## ADDENDUM 001

DATE: May 14, 2025  
COMM NO: 24058  
PROJECT: Vinton War Memorial Park

TO: All Bidders  
FROM: Mike Woolwine  
RE: Addendum 001

CONCRETE BORDER DETAIL

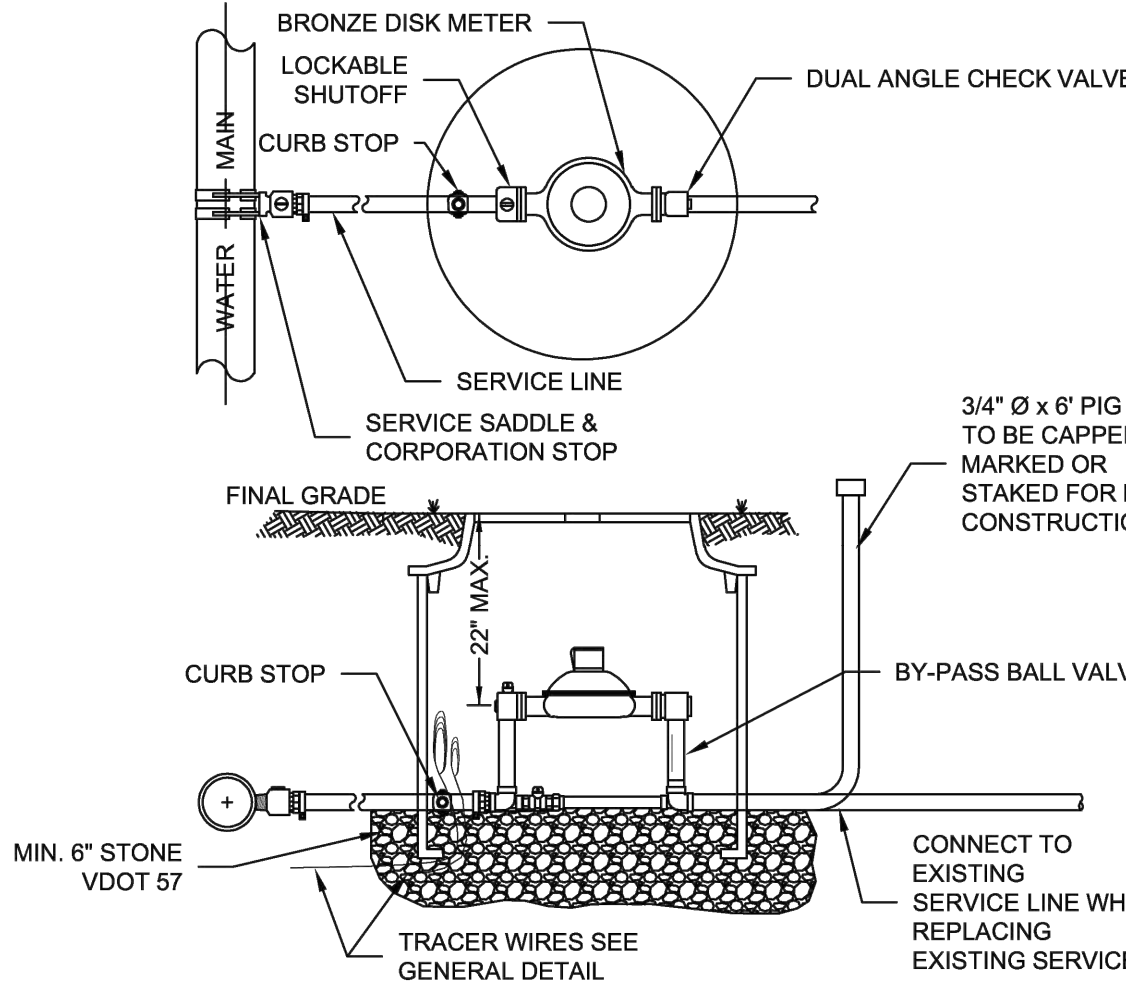
1. **Comment:** Pre-bid sign-in sheet attached.
2. **Comment:** Revisions to Sheet CO.1
  - a. Added concrete border detail
  - b. Added Pickleball Court Pavement Section (Was changed from concrete to asphalt)
  - c. Revised Sidewalk Section – (Base stone under sidewalk 4".)
  - d. Added Skate Park Pavement Section
3. **Comment:** Added New Sheet CO.2
  - a. Added exterior steps detail
  - b. Added Handicap Ramp detail
4. **Comment:** Revisions to Sheet C1.0
  - a. Added a tree to be removed
5. **Comment:** Revisions to Sheet 3.0
  - a. Pickleball Court surface was changed to asphalt pavement.
  - b. Concrete border added around pickleball court
  - c. Concrete border added around Botanical Garden

- NOTES:
- CONCRETE BORDER TO BE USED AROUND PLAYGROUND AREAS AND ASPHALT PAVEMENT OF PICKLEBALL COURT AS INDICATED ON THE PLANS.
  - THE CONCRETE BORDER SHALL BE CONSTRUCTED WITH VDOT A4 AIR ENTRAINED CONCRETE. TOOLED JOINTS REQUIRED EVERY 10' ON CENTER AND 1/2" PREMOLDED EXPANSION JOINT FILLER 30' MAX ON CENTER

LIGHT DUTY ASPHALT PAVEMENT SECTION

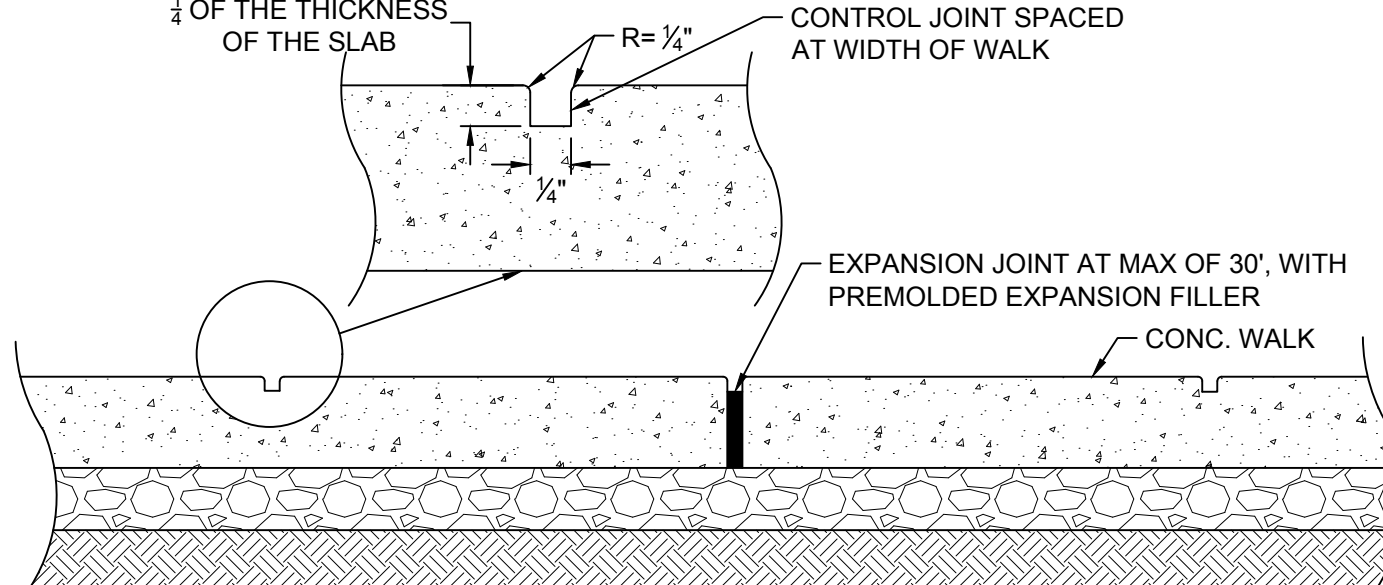
9. **Question:** Are unit prices included in base bid?
  - a. **Response:** Yes, include in base bid for the specified quantities. Added on the Bid Form 00 4100, paragraph 1.05.G

- F. Remove and Replace Asphalt Pavement - 400 sy @ \$\_\_\_\_\_ per square yard.
1. For pavement replacement refer to plans for Light Duty Asphalt Pavement Section.

PB-1

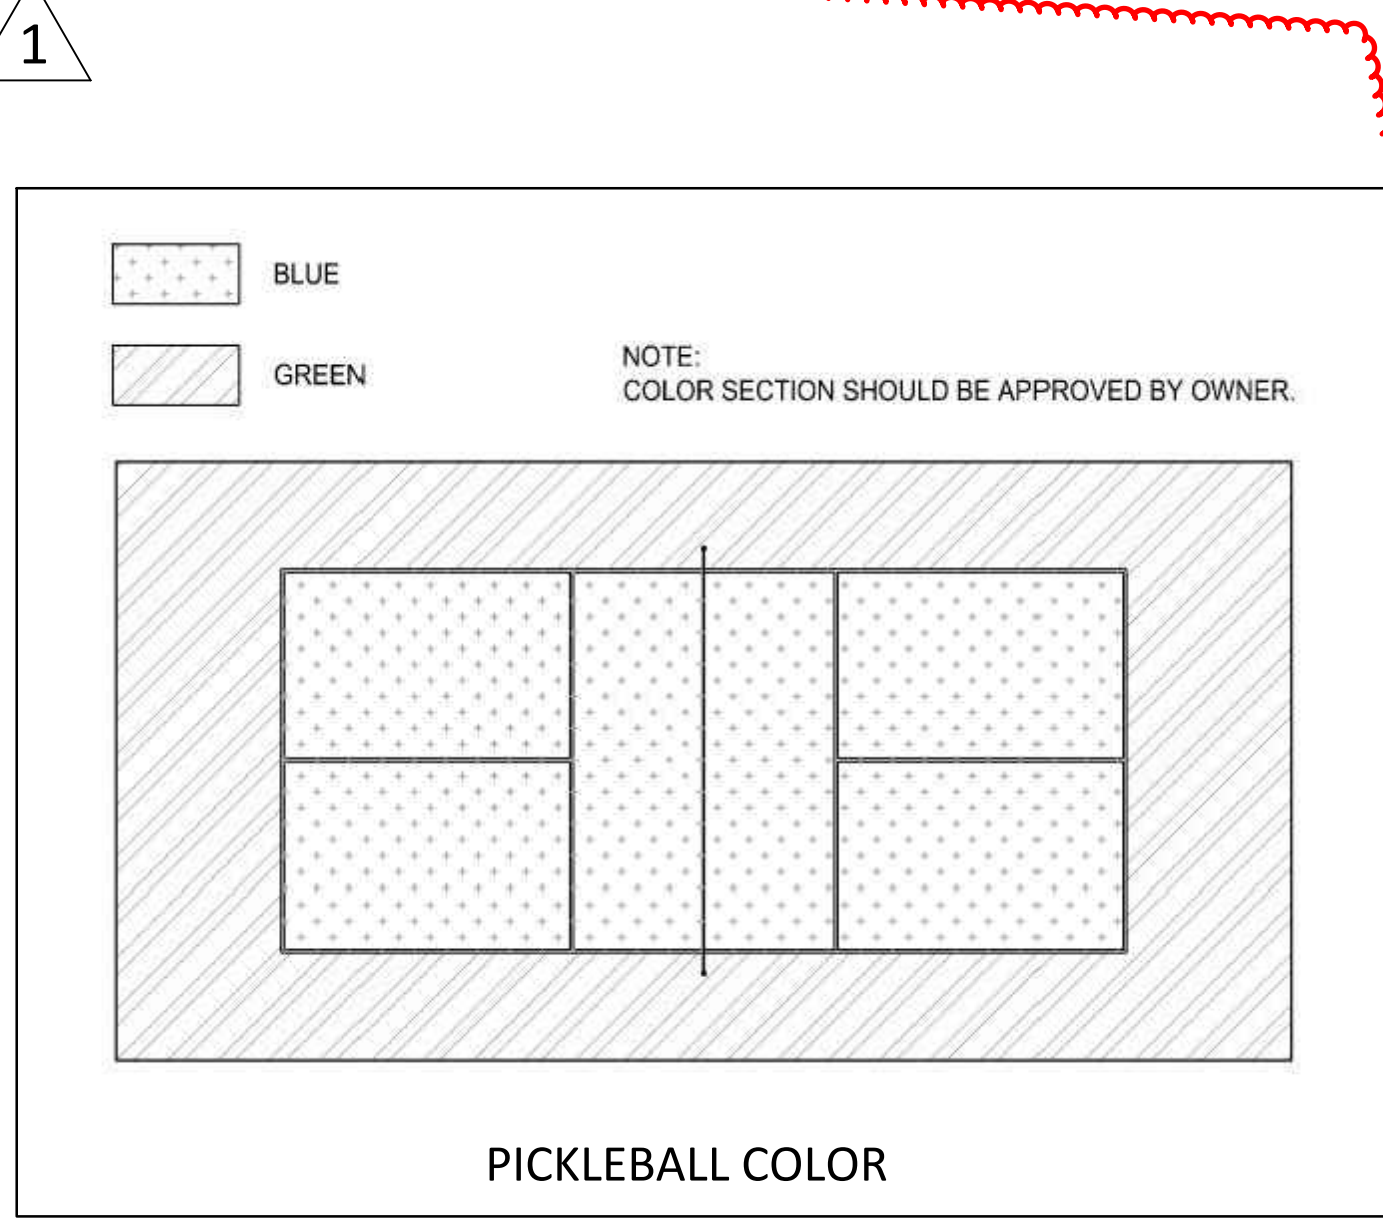
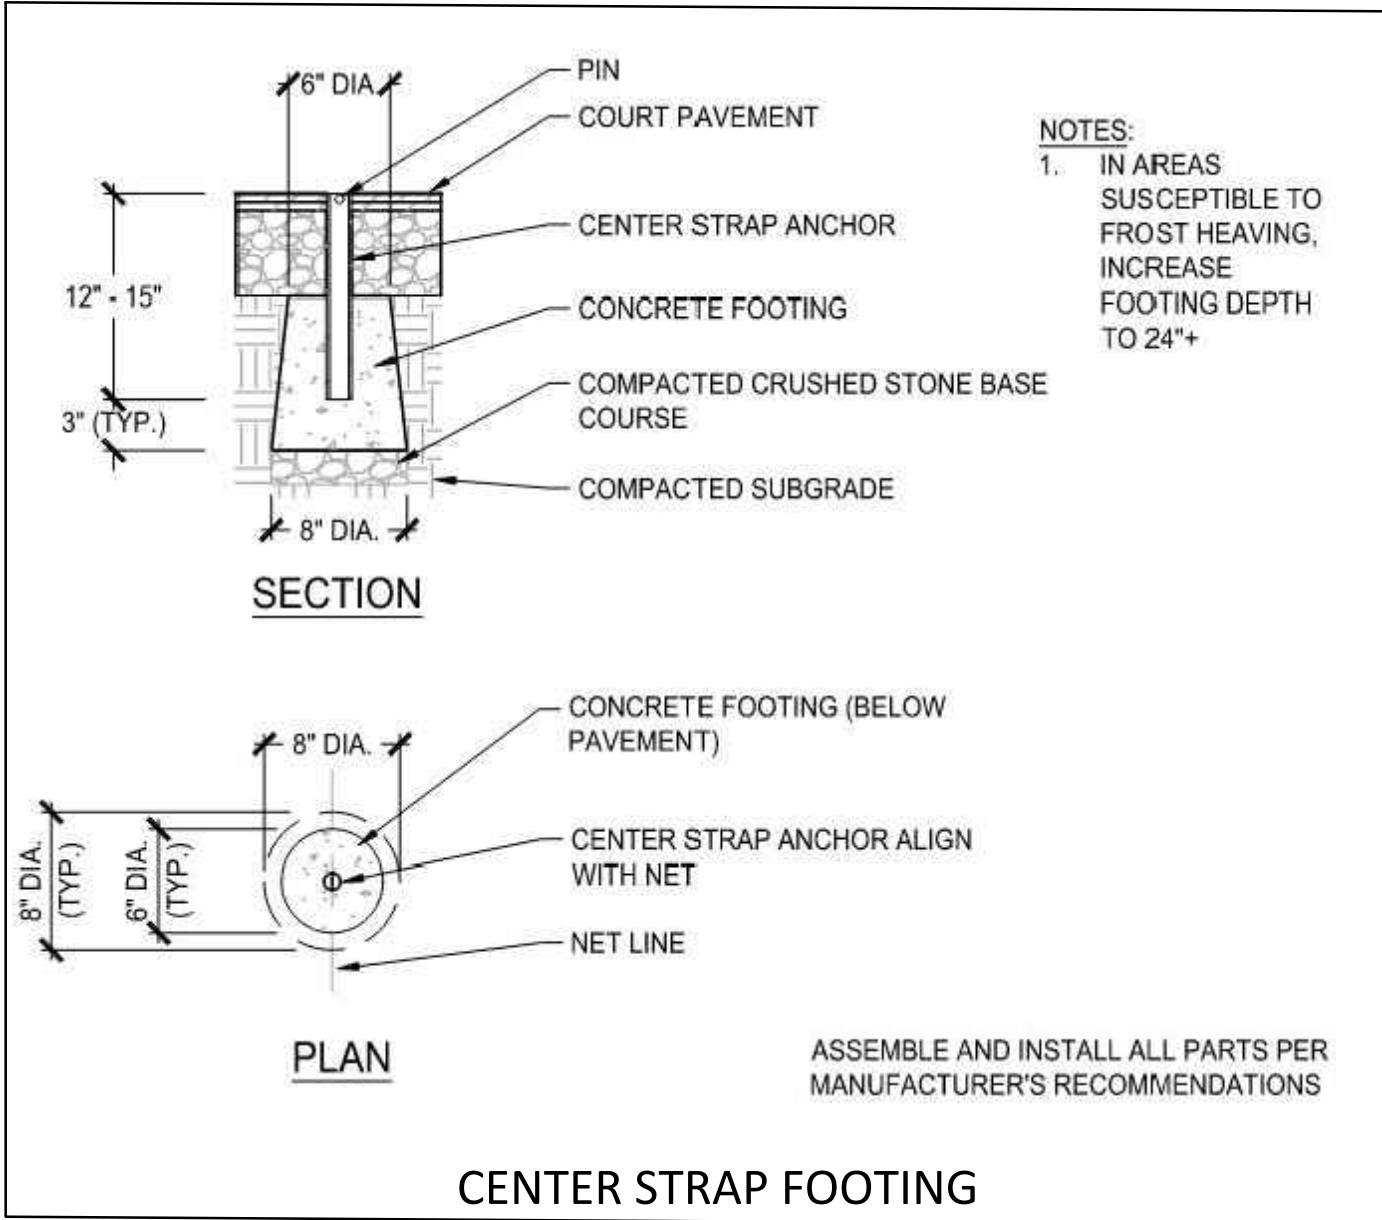
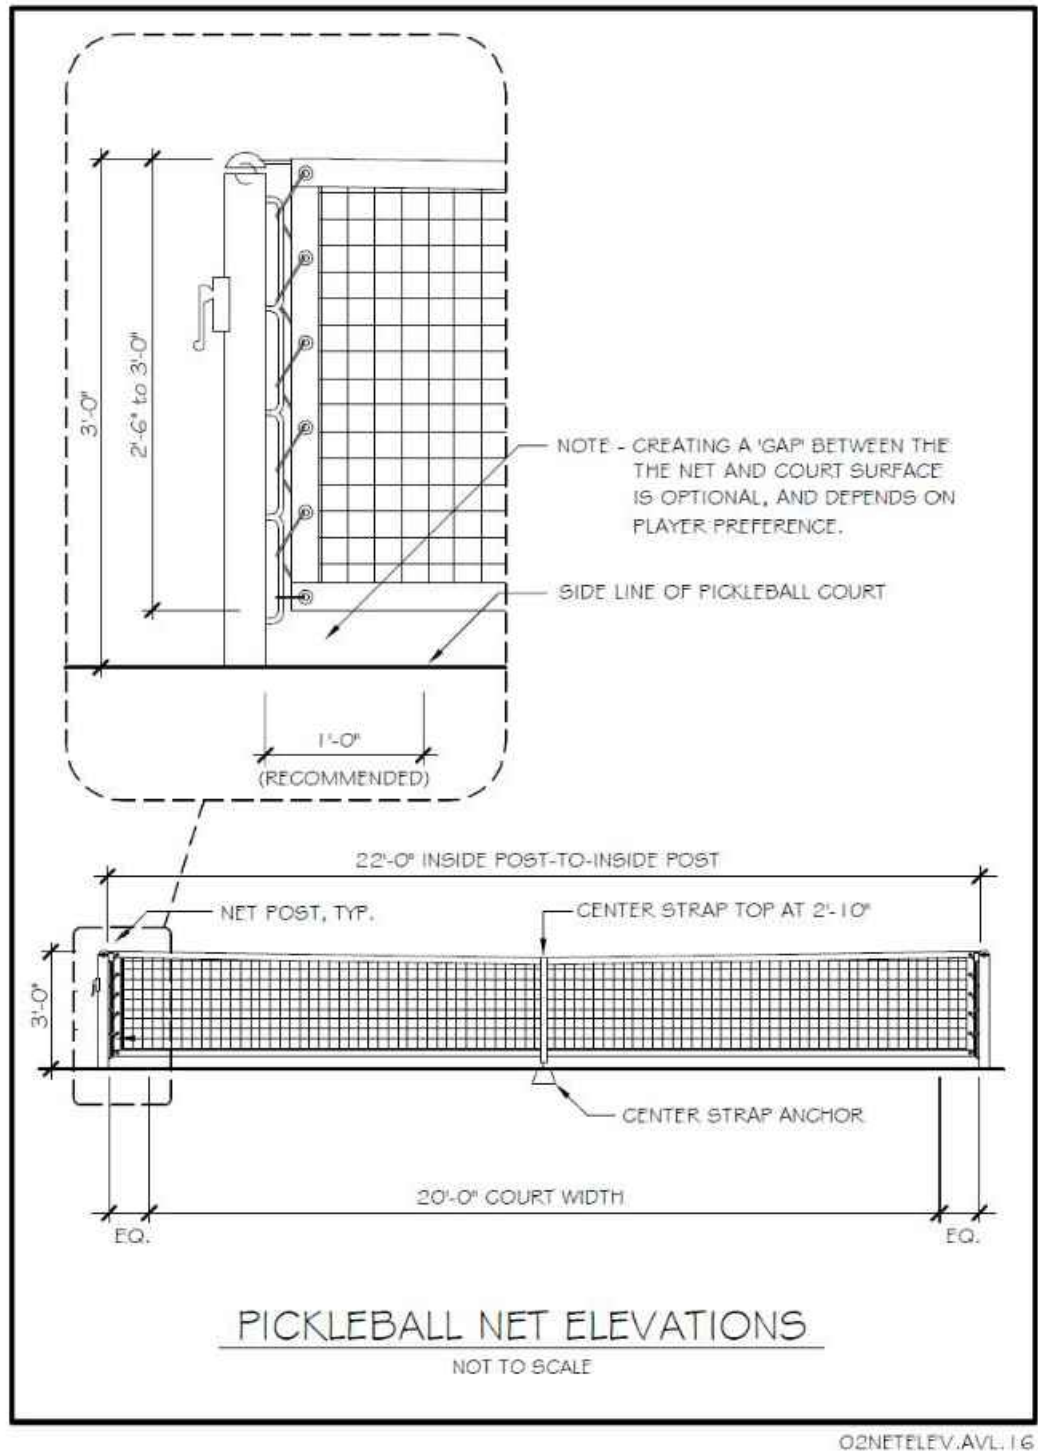
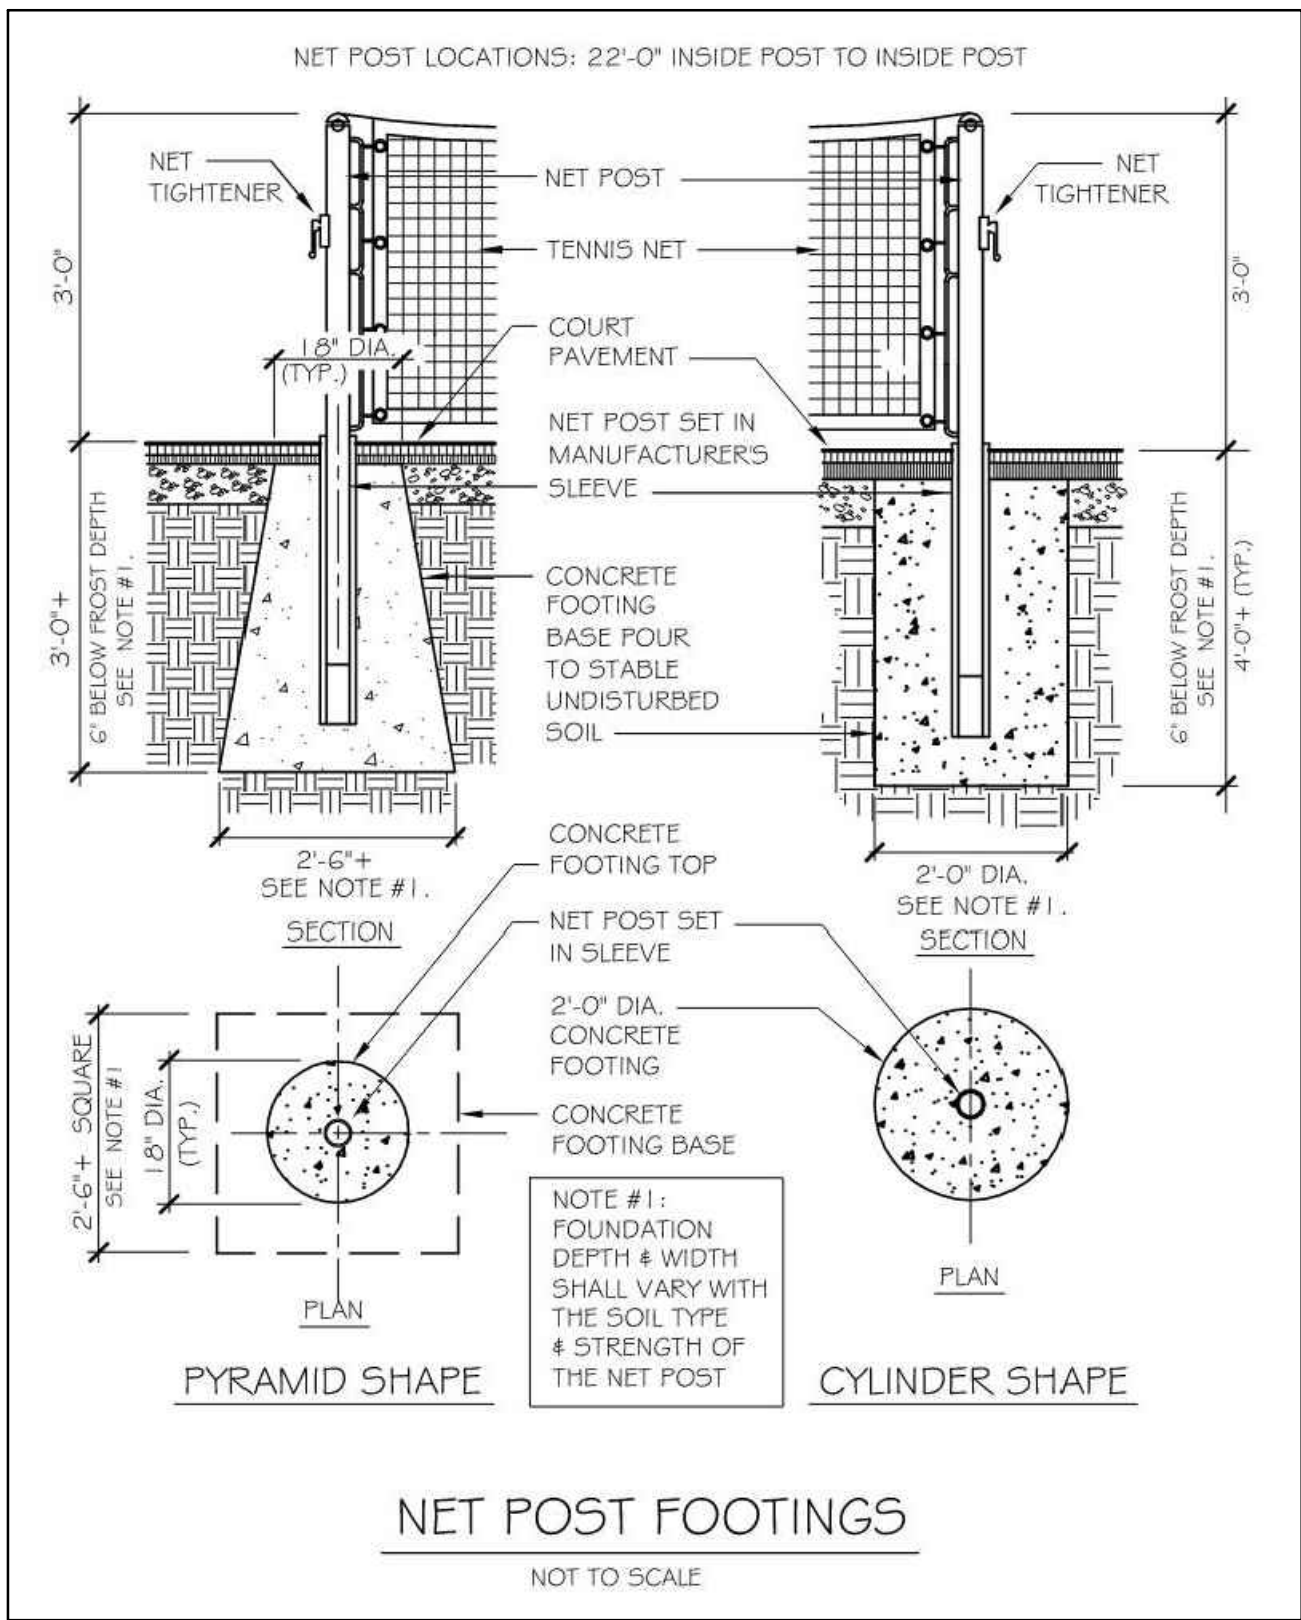
6. **Comment:** Revisions to Sheet PB-1
  - a. Added a Center Strap Footing Detail
  - b. Added a pickleball color plan
  - c. Removed information on pickleball surface coating for concrete
7. **Comment:** Added a Unit Price to Remove & Replace Asphalt Pavement on the Bid Form 00 4100, paragraph 1.08.F
8. **Comment:** Contact information for the playground company and the installer.
